# **ECE R129 Phase 2 Envelop Fitting**

# CRS-59-08e Proposal R16 add B2 B3 for IG CRS

Figure 2 - ISO/B2

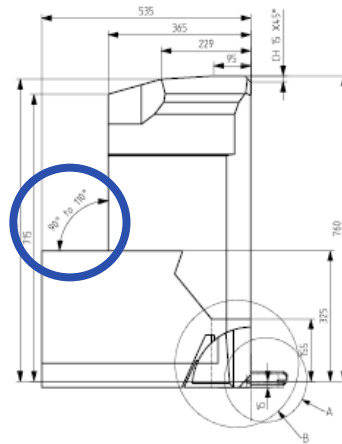
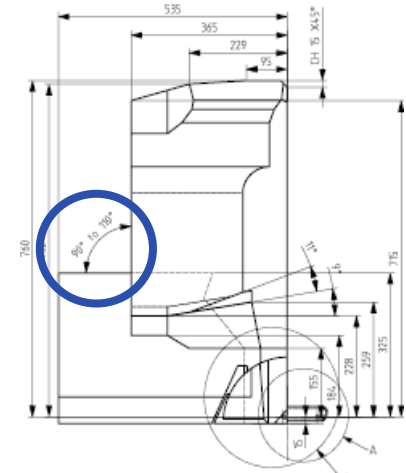
- Since the envelop is articulated, how to check that CRS fits into the envelop, CRS may fit in one angle position (i.e. 110°) and not in the other ones (i.e. 90°)
- Annex 17 Appendix 5 Open to interpretation, the text refer to CRS adjustability or to envelop, or both.

This interpretation can cause the possibility that some CRS can't be installed into a vehicle approved for the same class of Vehicle Seat Fixture

I-size compatibility with the VSF, shall be guaranteed at least in one ECRS position in all backrest angle range (90°-110°); ECRS position can be changed through backrest angle range to fulfill requirement (i.e. CRS adjustment and configuration to fulfill 90° backrest VSF angle requirement can be different than the one which fulfills 110° backrest VSF angle);

Vehicle Specific ECRS compatibility with VSF shall be guaranteed at least in one ECRS position at one backrest angle.
